31 Milton Park, Hornsey, London, N6 5QB

RESPONSE TO COMMENTS RECEIVED FROM HARINGEY BOUROUGH COUNCIL – 07.06.2023

Comments have been received from Haringey Borough Council (HBC) Planning Office regarding arboricultural matters for the proposed development at 31 Milton Park, Hornsey, London, N6 5QB.

Figure 3 (left): Largest area of proposed relative impact within a standard circular RPA where proposed development sees an increase of intensity and change of context from hard surfacing to building foundation

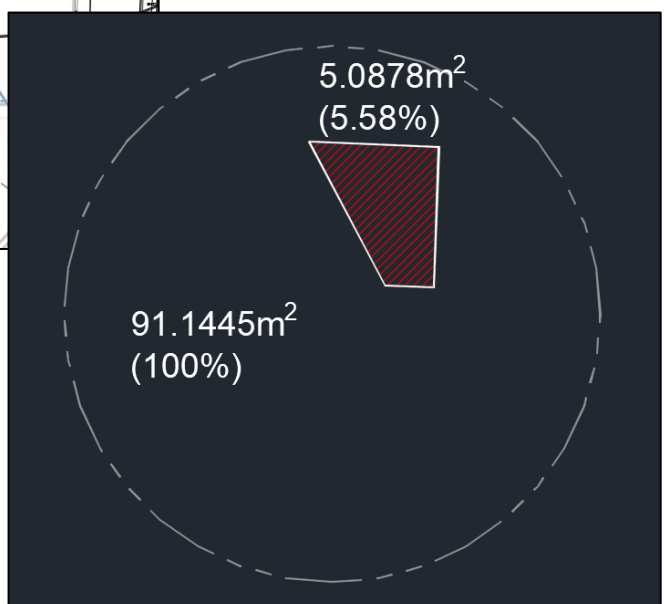
HBC – “No information has been given within the document of the actual percentage encroachment of the new proposed extension into the RPA. From the plans it looks quite extensive.”

ACD – The area of new construction encroachment into the RPA of T5, which sees the biggest relative incursion into its RPA from the proposals, has been measured in AutoCAD as 5.6% of the overall required RPA area as calculated in line with BS5837:2012 for single stemmed trees ($\varnothing \times 12$) – this area of impact would be further reduced if the RPA were to be offset to favourable rooting medium offsite. It is further considered that the area of proposed incursion is within an existing hard surface of cast concrete, with a noticeable drop in ground levels within the development boundary which will have likely suppressed the establishment of rooting systems in this area. For areas of RPA reaching beyond the shown area of impact, the context of development will not be changing (from building construction/foundation) and therefore no additional impact is considered.

Figure 5 & 6 (above): TP1 with single root of approx. 19mm – 20mm $\varnothing$

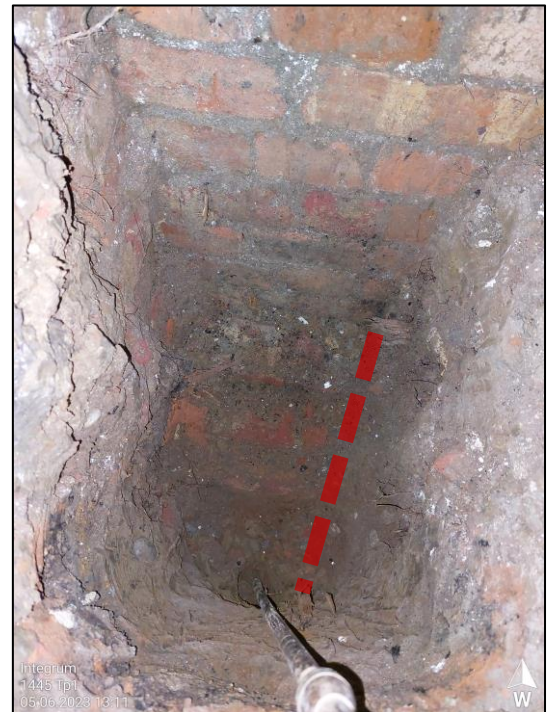
- HBC – *“Foundation design has not been decided due to the proposed trial trenches. However, considering the extent of the encroachment into the RPAs, particularly T5, piling seems the appropriate solution.”*

- ACD – Where the proposed development footprint follows the line of the existing brick building foundations, there should be no need to specify bespoke foundation design as there is not likely to be any significant additional impacts to potential rooting systems in these areas. The findings of x2 recently excavated chambers (“TP1” & “TP2”) show that only minimal rooting presence of >10mm^Ø was found in an area along the proposed area of new foundation line within the RPA of T5 (TP2), and within the existing basement (TP1) where a new staircase is to be installed, a single root of approximately 20mm^Ø was found – this larger root is on the lower threshold of what would be considered a significant root, however it is far from what would be considered a structural root that has an integral role in relation to the overall stability of a tree.

Even with these findings showing reduced rooting presence, sensitive and supervised methodology is to be used in these areas to ensure that if any large roots are found during further excavations, that appropriate steps which have been agreed and approved by Haringey Borough Council can be followed.

Further to this it is also considered that *Tillia sp.* as a species is incredibly tolerant of pruning with considerable ability for fast sealing and regrowth. Pruning of rooting system as represented by the findings of the recent trial pits would be considered to well within the threshold of what a tree of this species could handle and not be of a significant detrimental impact to the ongoing vitality of the trees anymore than the significant ‘pollarding’ regime that they are already subject to.
